BID ADDENDUM NO. 3

OWNER: EDGEMONT UNION FREE SCHOOL DISTRICT

PROJECT NAME: ADMINISTRATION BUILDING ADDITION,
SITE IMPROVEMENTS & RELATED WORK

DATE: March 21, 2025

SHEET SIZE 30"x42"	DRAWING NO. AD M100
SCALE AS NOTED	FILE NO. 24529.02
DRAWN BY LFG

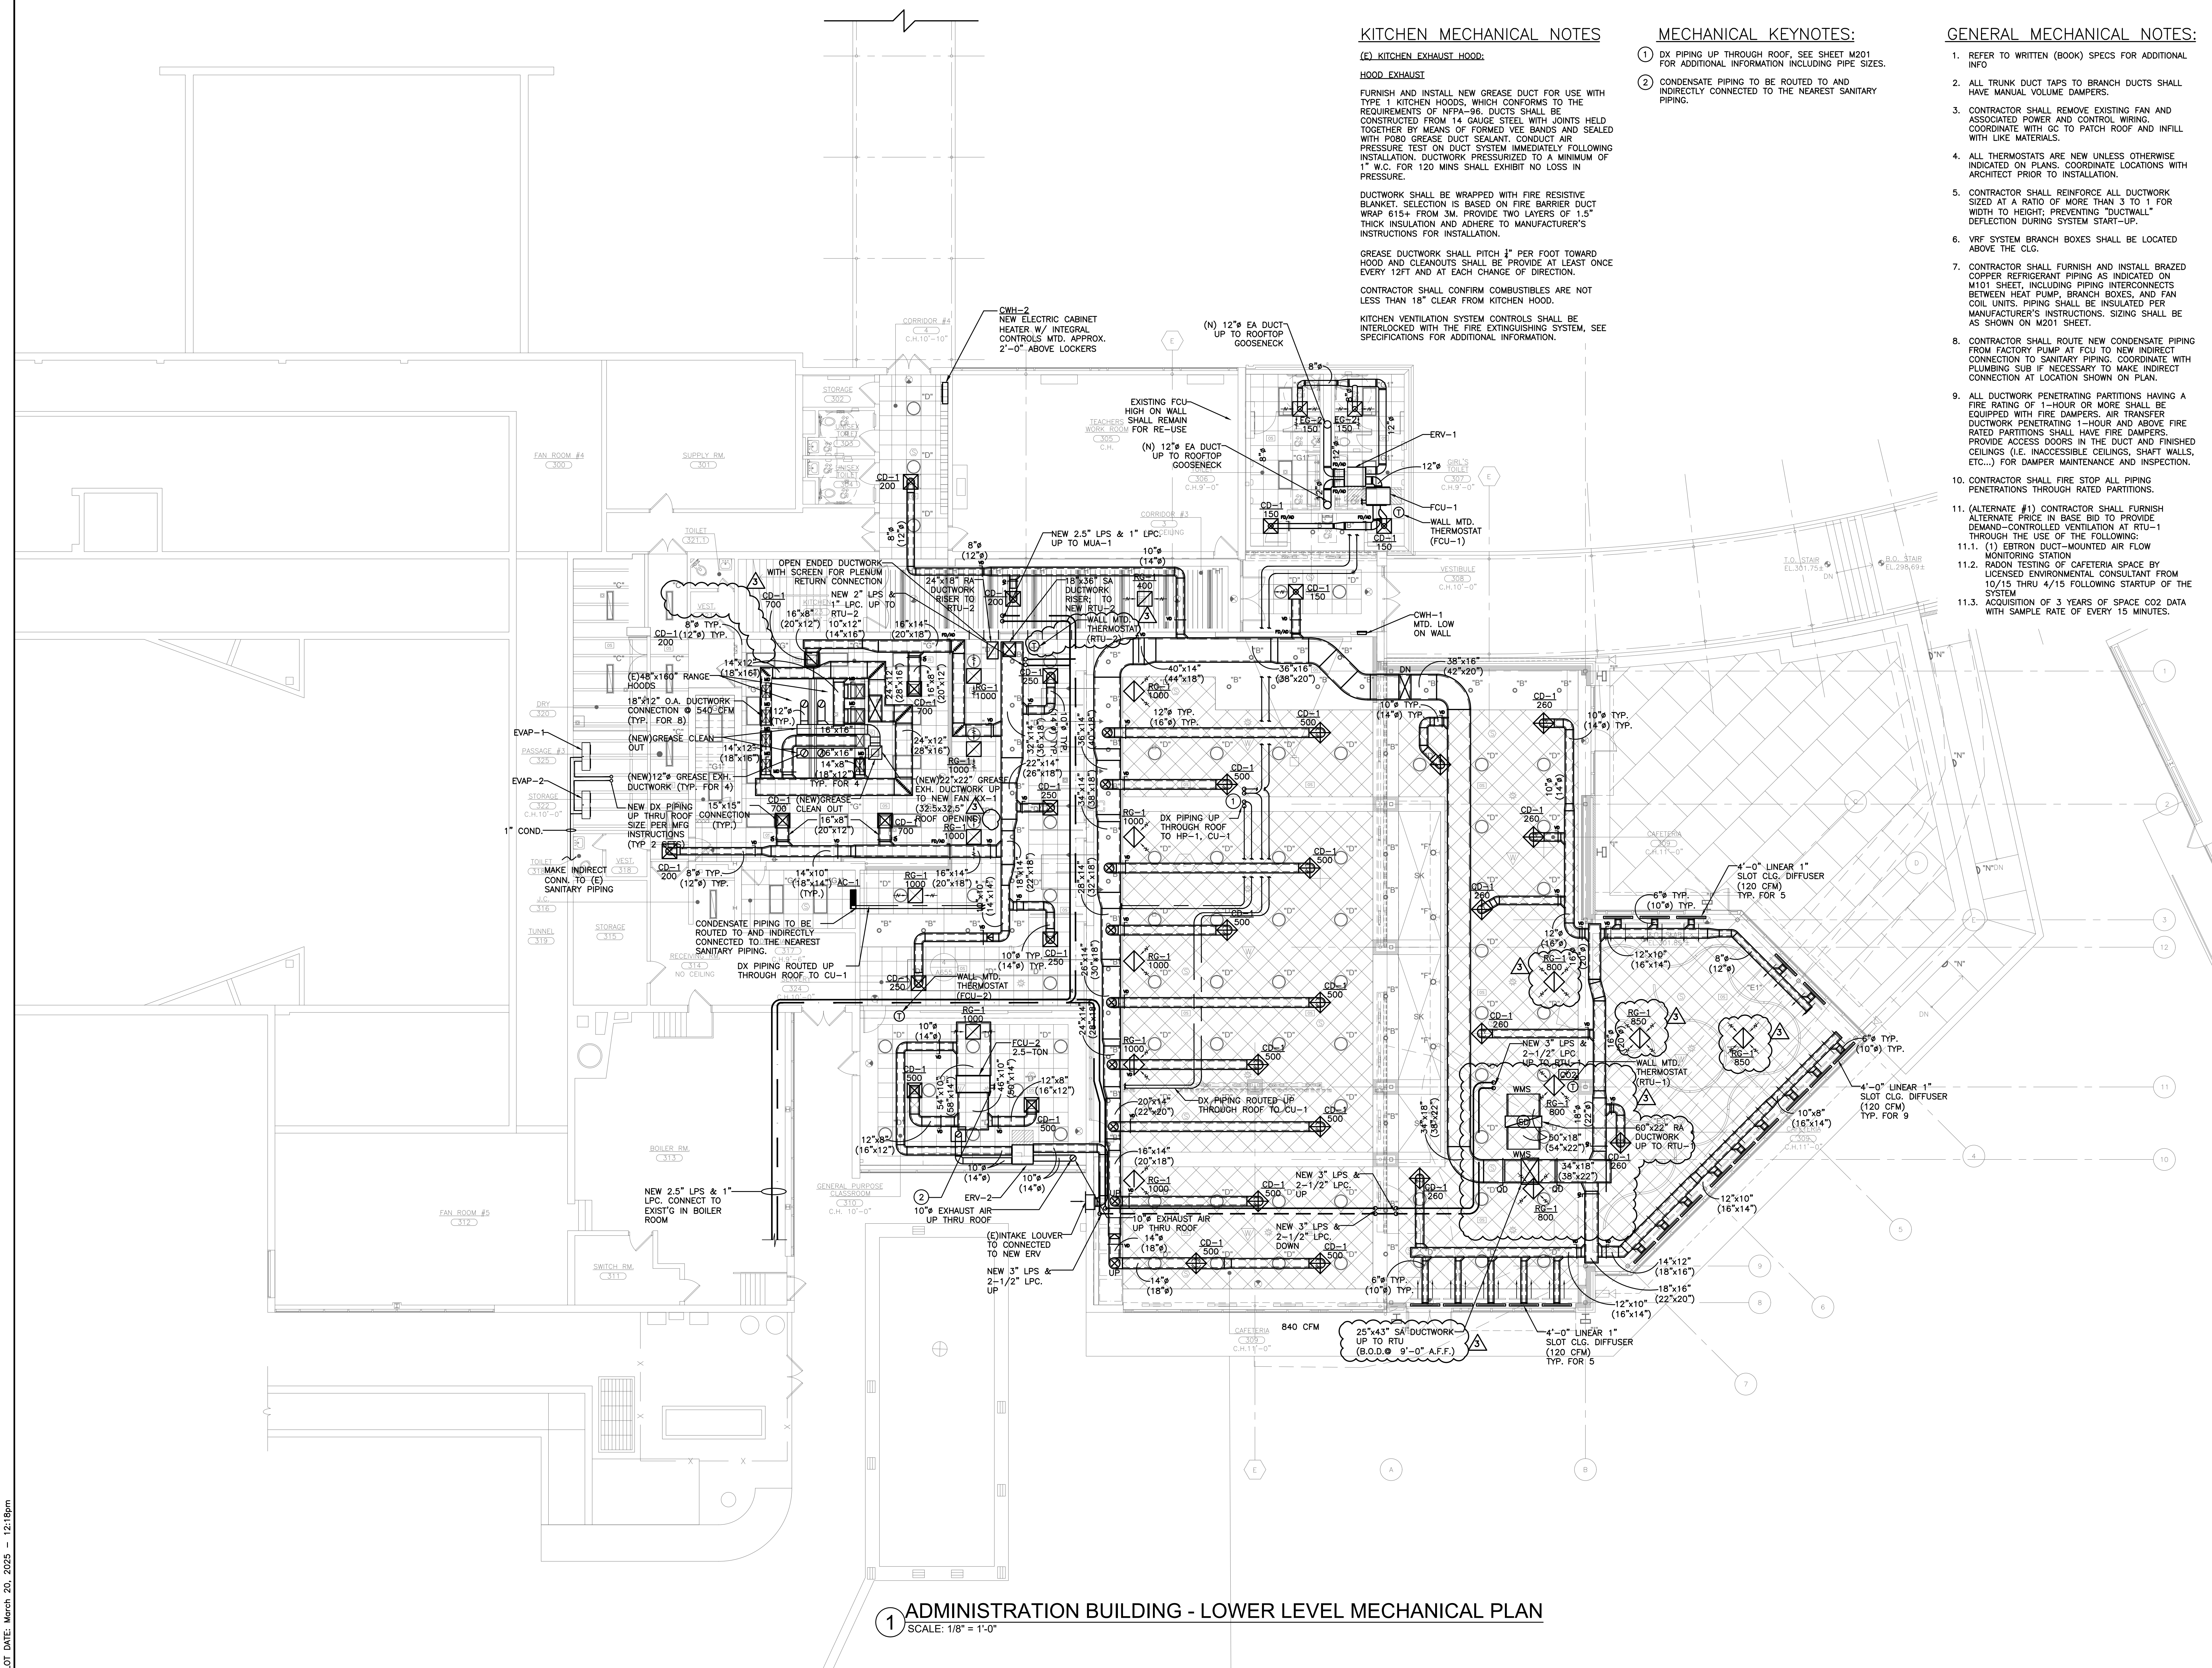
DRAWING AD M100 – “ADMIN.” BUILDING LOWER LEVEL MECHANICAL PLAN

REVISE ductwork as shown on revised drawing attached to this addendum.

DRAWING NO.
AD
M101
FILE NO.
24529.02

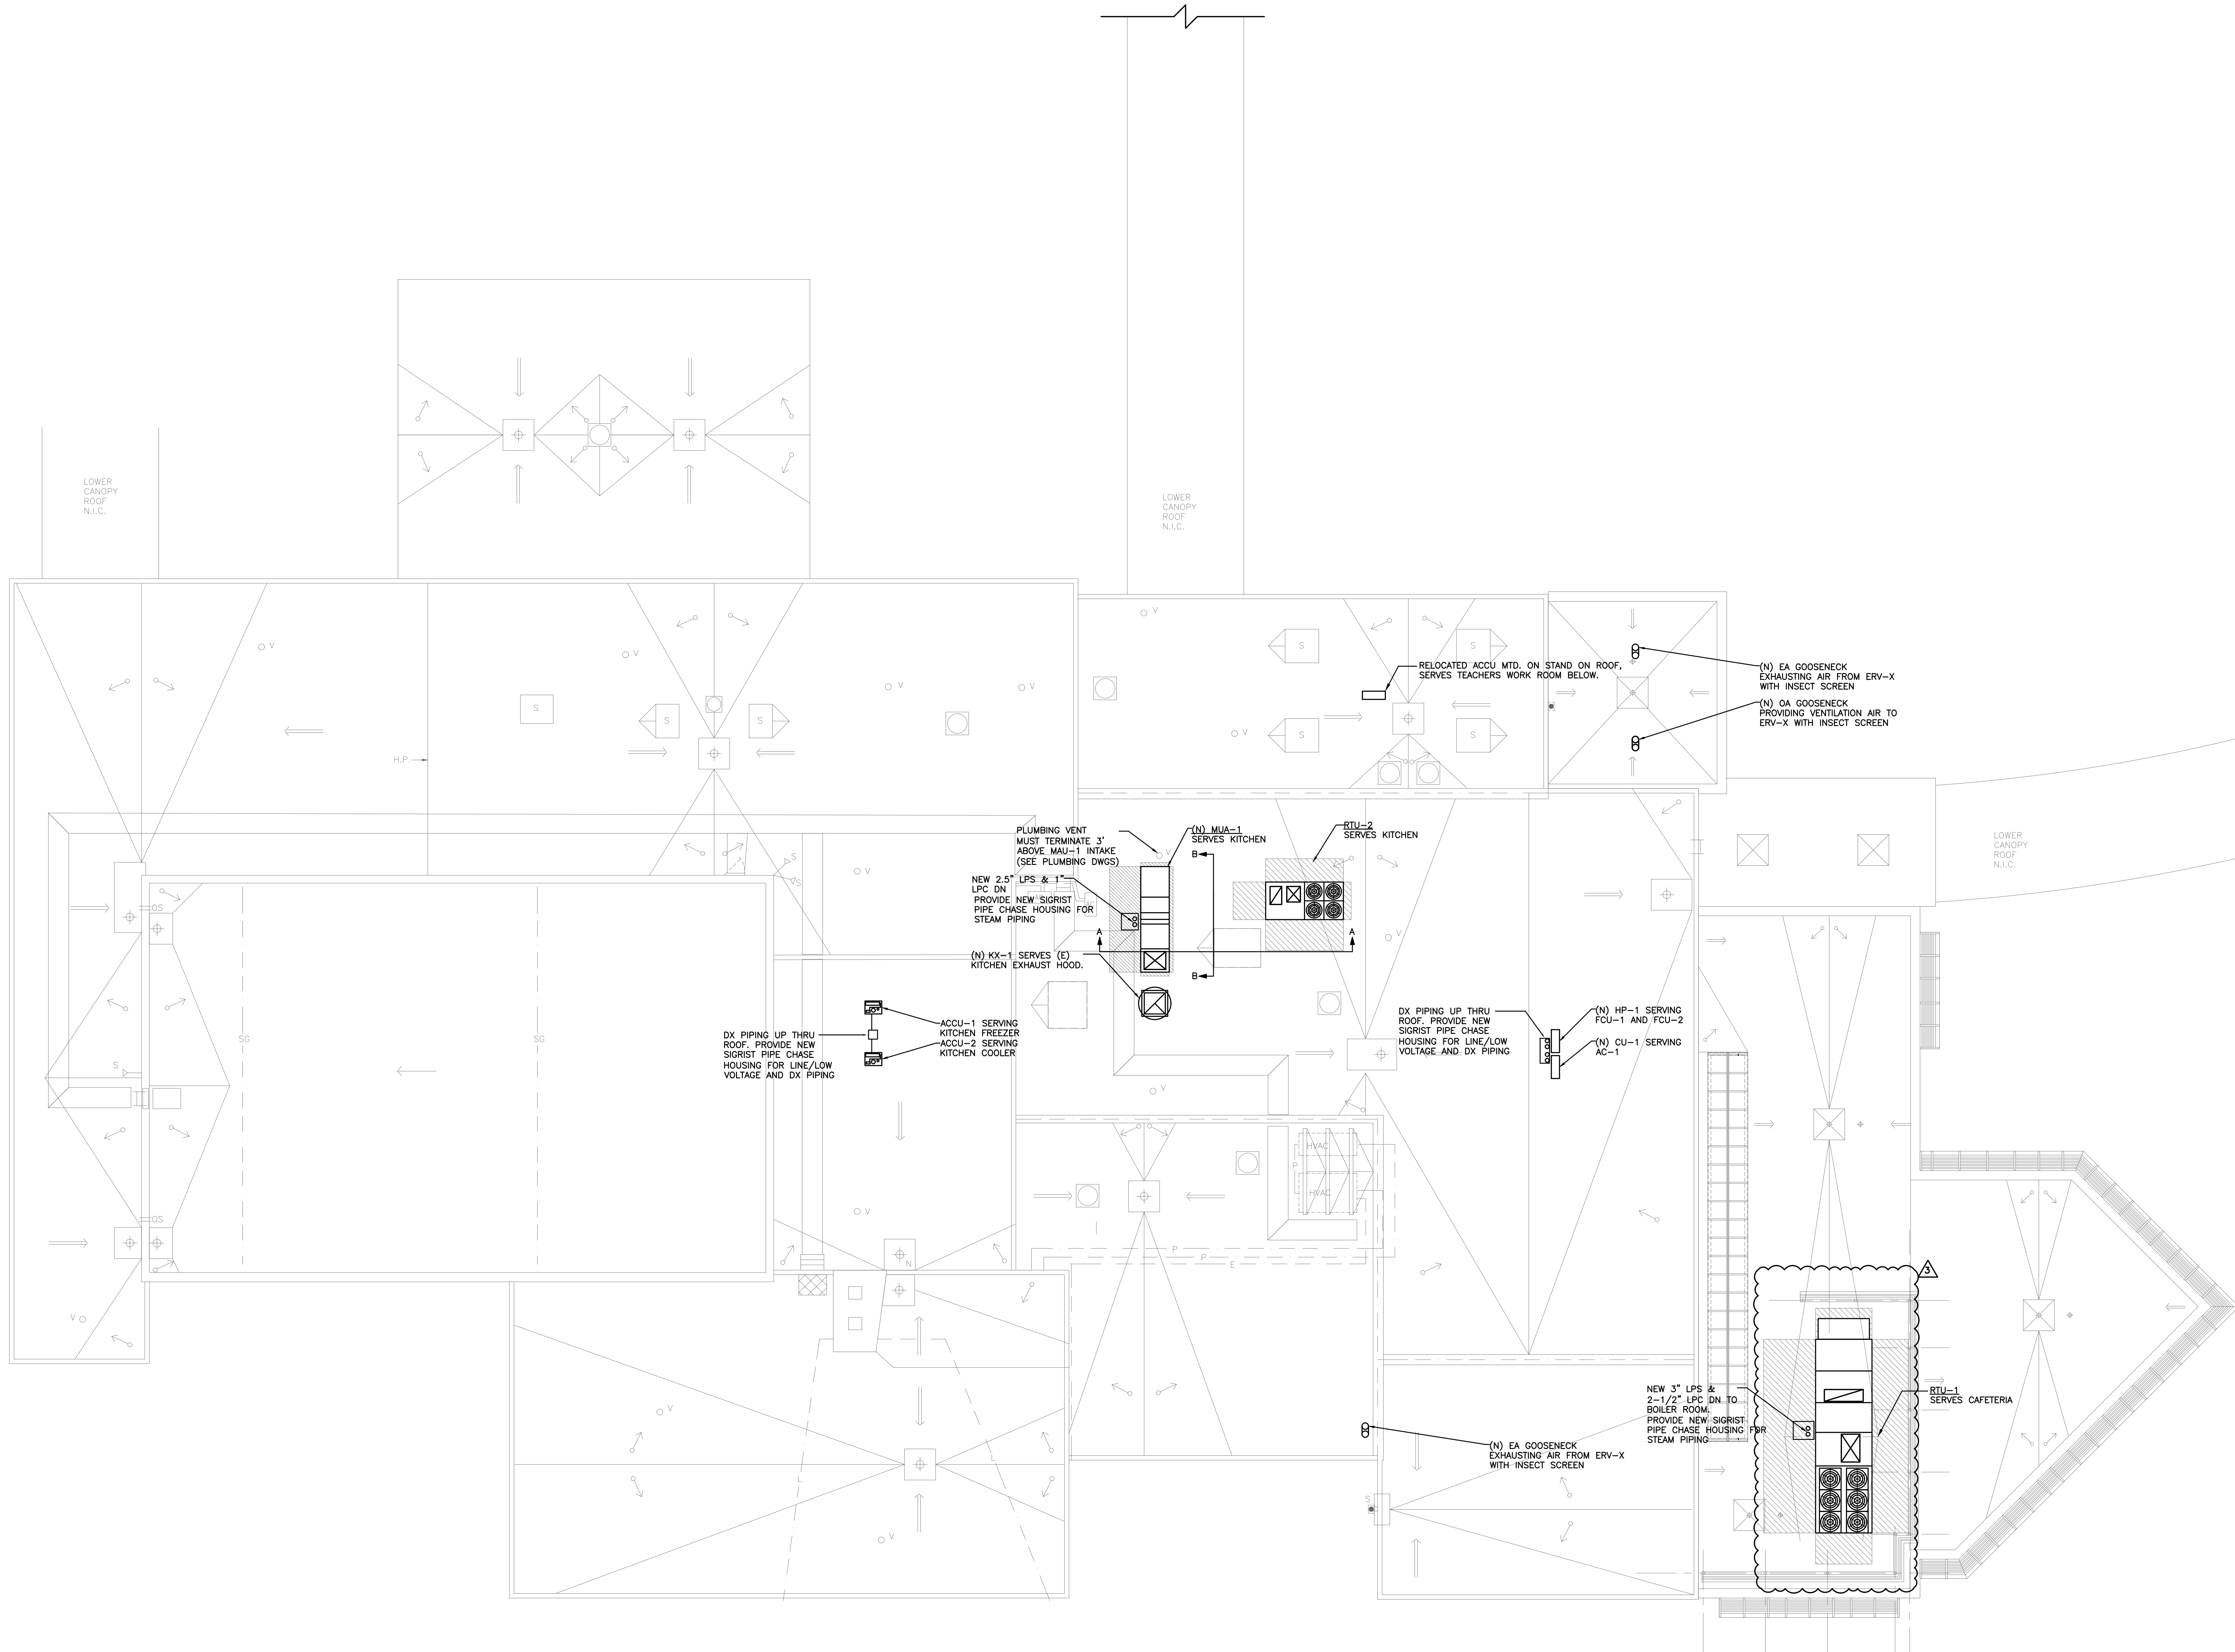
DRAWING AD M101 – “ADMIN.” BUILDING LOWER LEVEL MECHANICAL PLAN

REVISE size of RTU-1 as shown on revised drawing attached to this addendum.

03-20-2025	ADDENDUM #3
03-18-2025	ADDENDUM #2
03-12-2025	ADDENDUM #1
02-28-2025	BID SET
06-10-2022	S.E.D. SUBMISSION
DATE	ISSUED TO
SHEET SIZE 30"x42"	DRAWING NO. AD E101
SCALE AS NOTED	FILE NO. 24529.02
DRAWN BY LFG

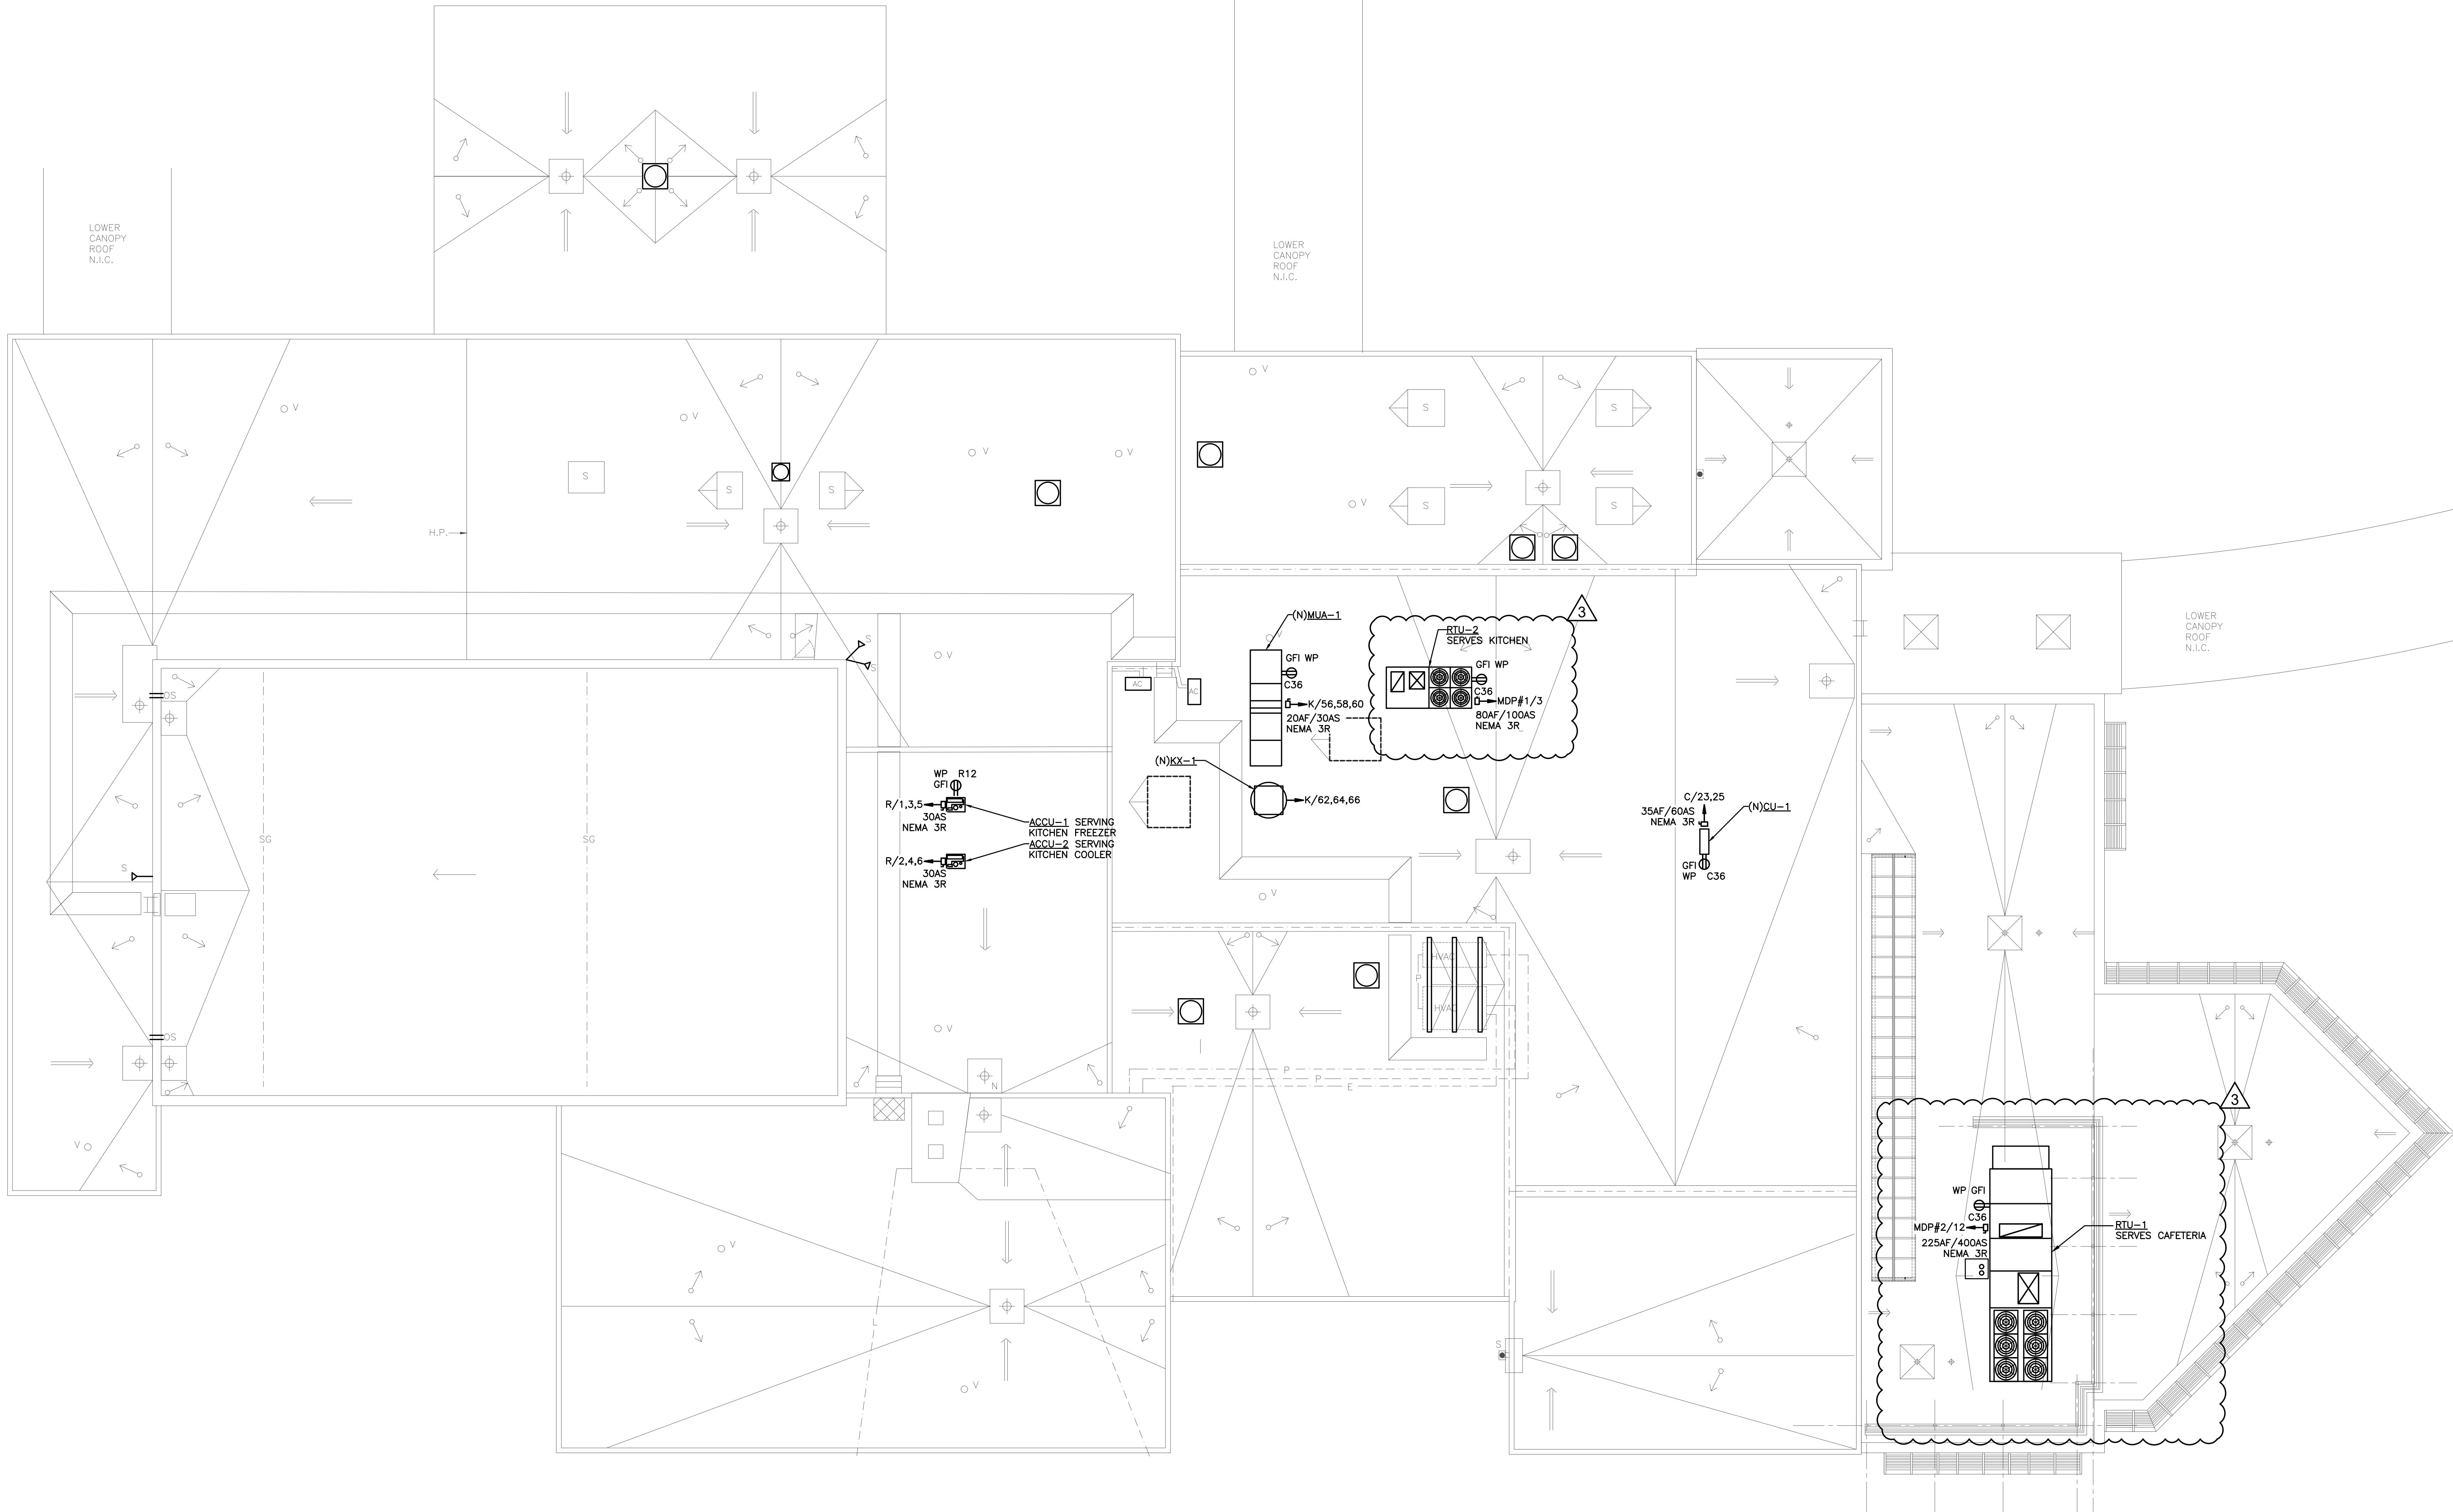
DRAWING AD E101 – ROOF ELECTRICAL PLAN

REVISE RTU electrical information as shown on revised drawing attached to this addendum.
